Access Compliance Report

Public Rights-of-Way

(Curb Ramps)

Intersection ID: 3438	Main Street: TREYBURN_DR	Cross Street: W_W_T_HARRIS_BV	Location: S
ADA ID: A40FDF5077A1	Ramp Type: BlendTrans2	Initial Pass/Fail: Fail	Overall Compliance: No
Severity Score: 8.75			
Codes/Mitigation Info/Possible Solution		Field Measurements/Component Compliance

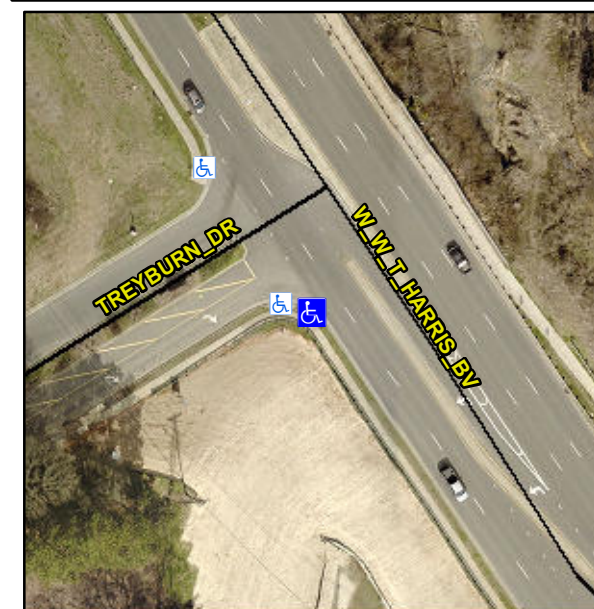
Not Found, R304.5.1

Remove & Replace Curb Ramp With Two New Directional Ramps or Equivalent.
